**Review of the
Bowers Wind Project
Visual Impact Assessment**

James F. Palmer

April 28, 2011

ArcScene Visualization 1: Bottle Lake

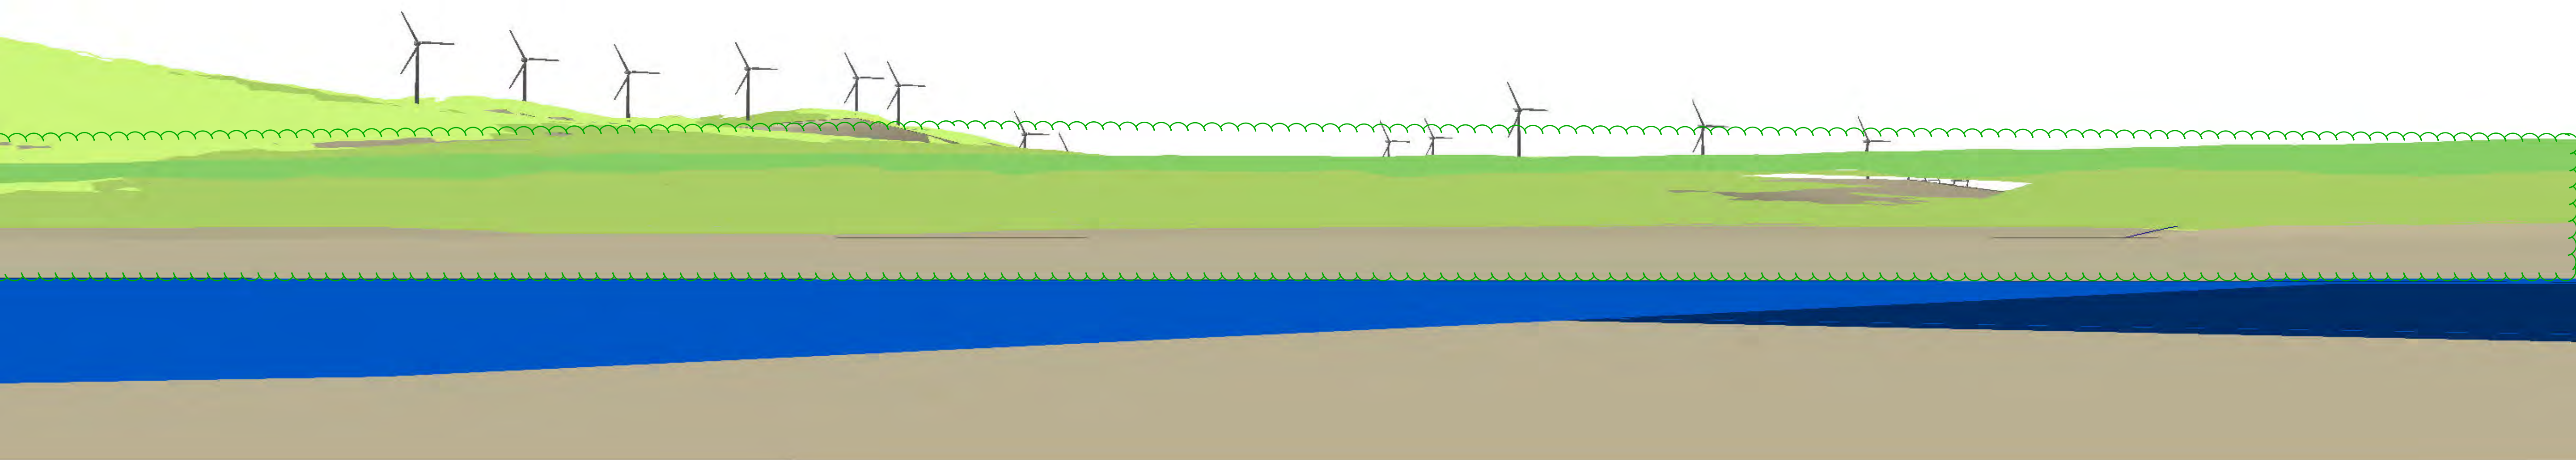
Bottle Lake. The scope and scale of Visualization 1 is very similar to the photosimulation in the VIA's Exhibit 6. This supports the accuracy of the photosimulation.

ArcScene Visualization 2: Duck Lake

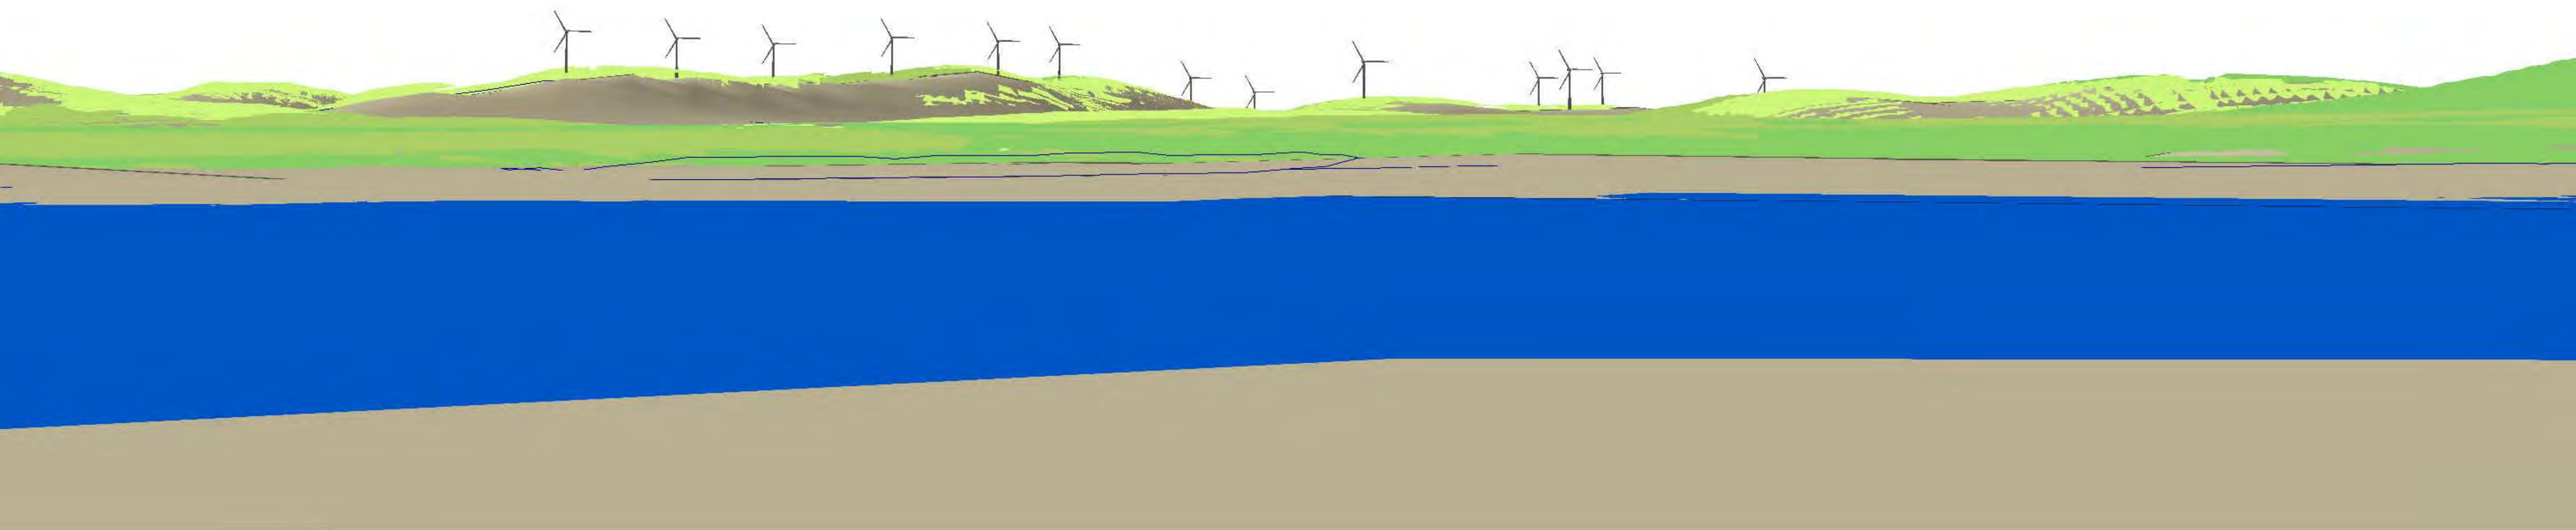
Duck Lake. The scope and scale of the left half of Visualization 2 is very similar to the photosimulation in the VIA's Exhibit 7. This supports the accuracy of the photosimulation. However on the right half there are turbines apparent in the visualization that are screened in the photosimulation. This appears to be because the shoreline vegetation is much higher than represented by the visualization. In the photograph, the tops of these trees are as high as the base of the sixth turbine from the left; it is clear that the shoreline vegetation is much lower in visualization. An approximation of the area that is screened by the shoreline vegetation is outlined by a scalloped green line. Considering this adjustment, the whole photosimulation appears to be accurate.

ArcScene Visualization 4: Keg Lake

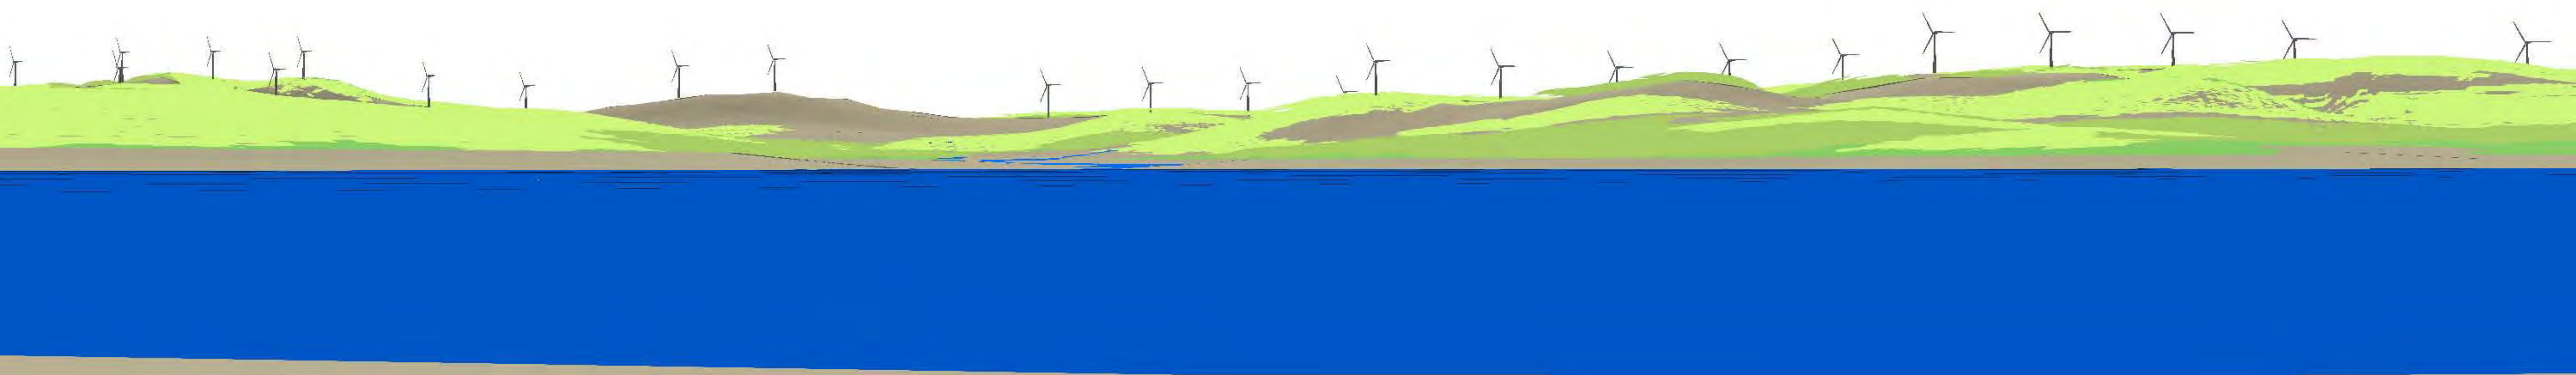
Keg Lake. The scope and scale of Visualization 4 is very similar to the photosimulation in the VIA's Exhibit 9. Shore vegetation at the far right side of the photosimulation is not present in the visualization, but it does not affect turbine visibility. This supports the accuracy of the photosimulation.

ArcScene Visualization 5: Pleasant Lake Boat Launch

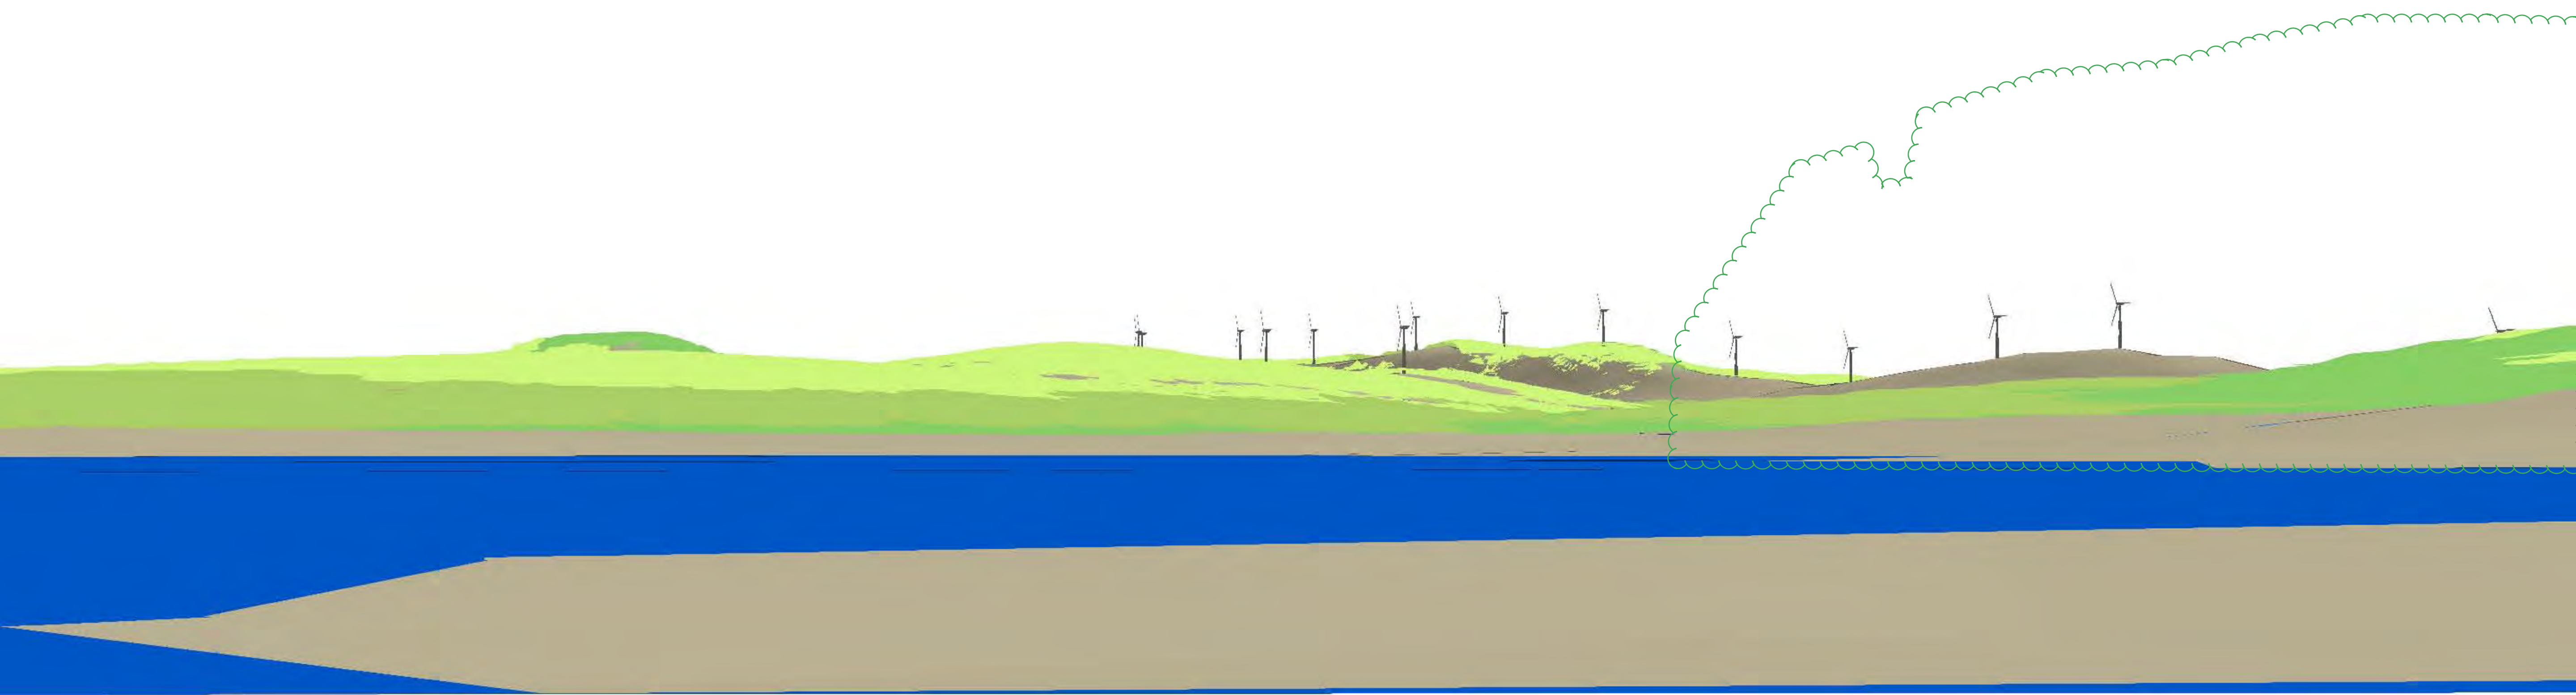
Pleasant Lake Boat Launch. The scope and scale of Visualization 5 is very similar to the photosimulation in the VIA's Exhibit 10. This supports the accuracy of the photosimulation.

ArcScene Visualization 6: Pleasant Lake, Near Northern Shore

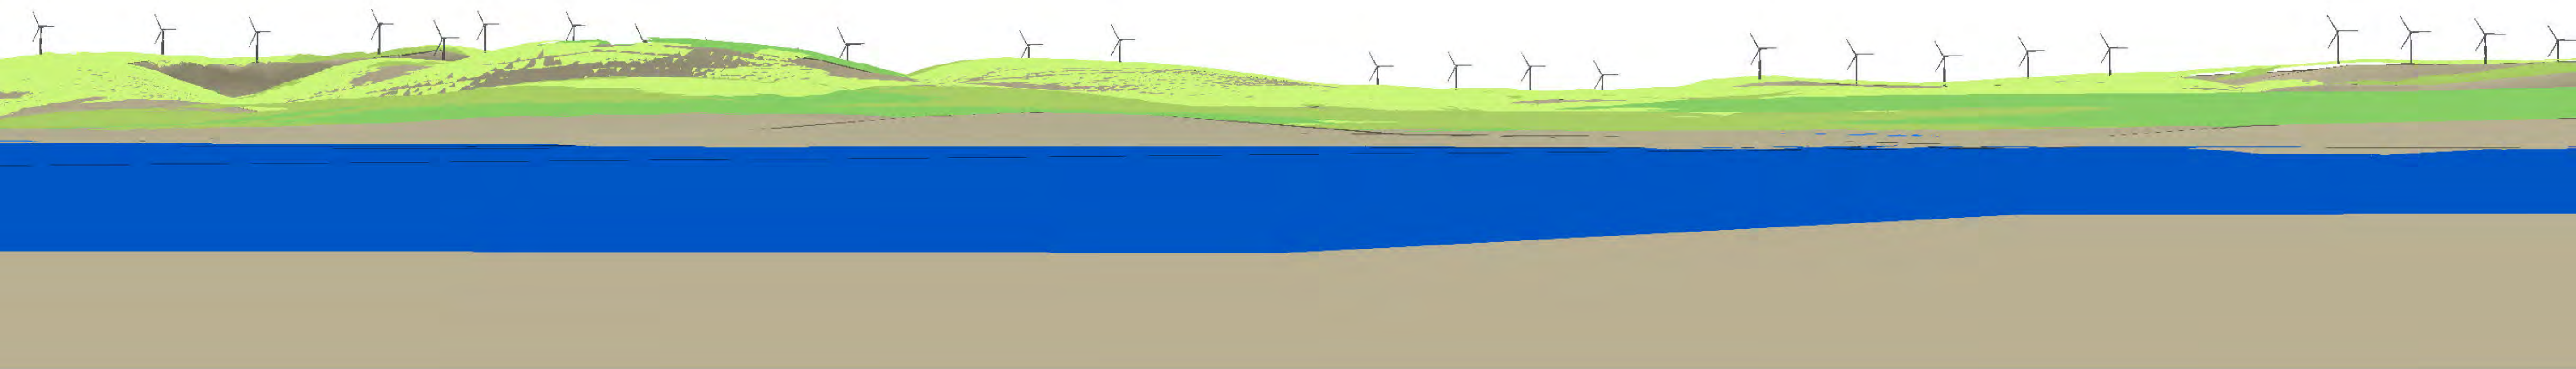
Pleasant Lake, Near Northern Shore. The scope and scale of the left and center portions of Visualization 6 is very similar to the photosimulation in the VIA's Exhibit 11. This supports the accuracy of the photosimulation. However on the right portion there are turbines apparent in the visualization that are screened in the photosimulation. This is because near-by shoreline vegetation not represented in the visualization will screen the turbines. An approximation of the area that is screened by the shoreline vegetation is outlined by a scalloped green line in the visualization. Considering this adjustment, the whole photosimulation appears to be accurate.

ArcScene Visualization 7: Scraggly Lake

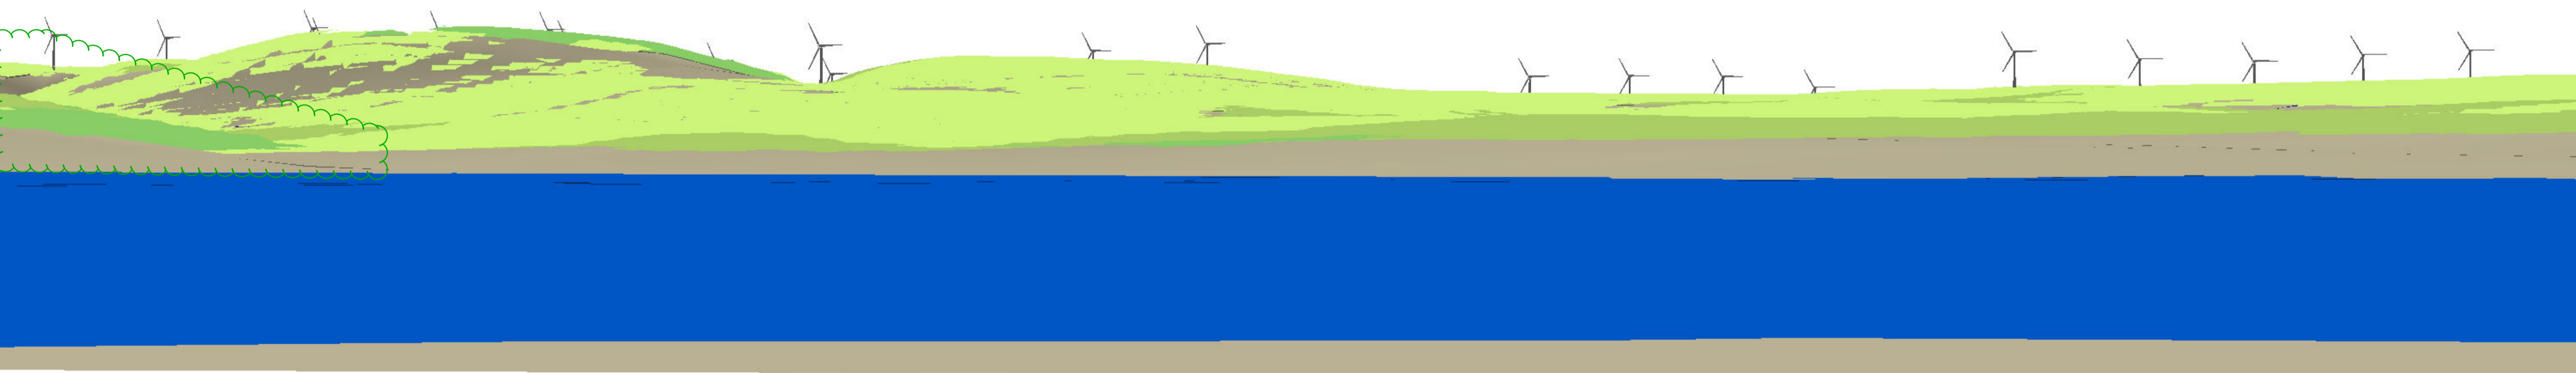
Scraggly Lake. The scope and scale of Visualization 7 is very similar to the photosimulation in the VIA's Exhibit 11. While the shoreline vegetation in the photograph is slightly higher than shown on the right side of the visualization, this will not significantly change the visual exposure of the turbines from this viewpoint. This supports the accuracy of the photosimulation.

ArcScene Visualization 8a: Shaw Lake

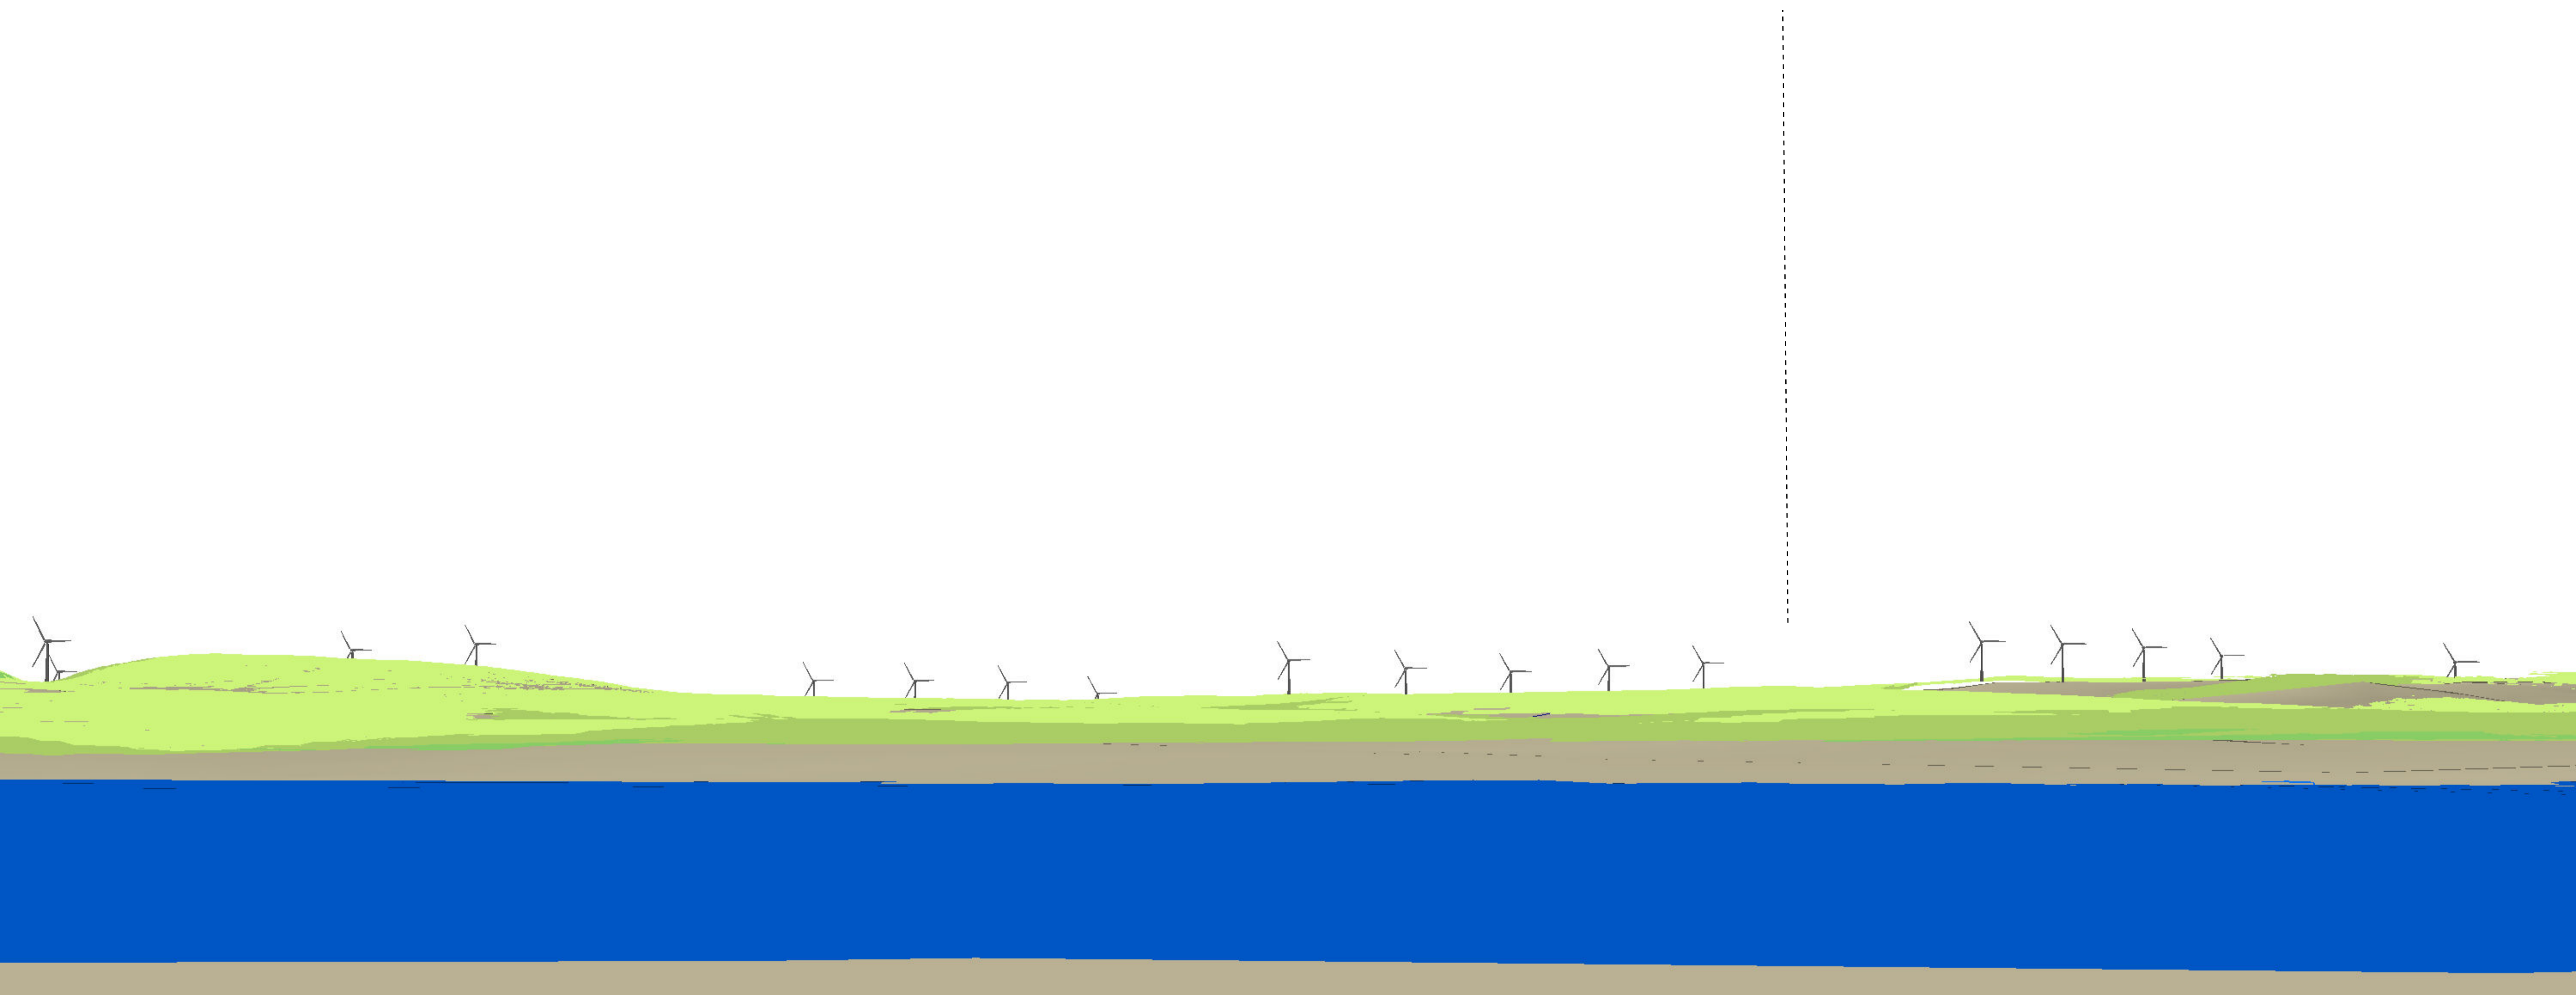
Shaw Lake. The scope and scale for most of Visualization 8a is very similar to the photosimulation in the VIA's Exhibit 13. However, shoreline vegetation will screen one turbine on the far left. This supports the accuracy of the photosimulation. Another issue concerns whether the photosimulation is too narrow to show all of the turbines that may be visible to the right. The photosimulation only extends on the right to turbine 22 and there is the possibility that turbines 23 through 27 are also visible to the right of the photosimulation, as illustrated in Visualization 8b: Shaw Lake.
